PRODUCT CHANGE NOTICE

1. TITLE MICROCIRCUIT, MEMORY, DIGITAL,CMOS, 1MEG X 39-BIT (40M), RADIATION-HARDENED DUAL VOLATGE, SRAM, MULTICHIP MODULE	**2. DOCUMENT NUMBER** SPO-2012-PCN-0009

CAES is working in coordination with DLA Land and Maritime to revise SMD 5962-10205, revision level B, for the following changes:

## ADDED: Alternative marking as package pin one indenifier to FIGURE 1. Case outline (sheet 11).

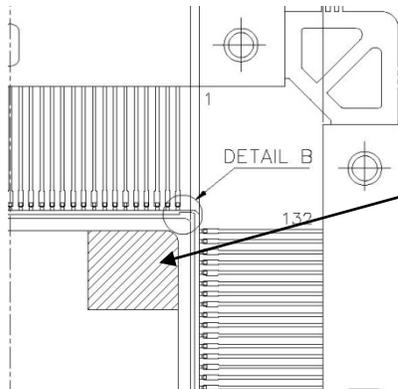
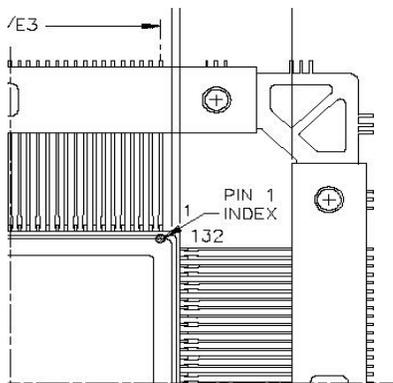
CORRECTED: Drawing of original pin one identifier corrected and detail B drawing added.

PREVIOUS: **CORRECTED:**

ADDED: Note 9 (sheet 12):

9/. A dot may be marked on lid to indicate pin 1 index within area shown.
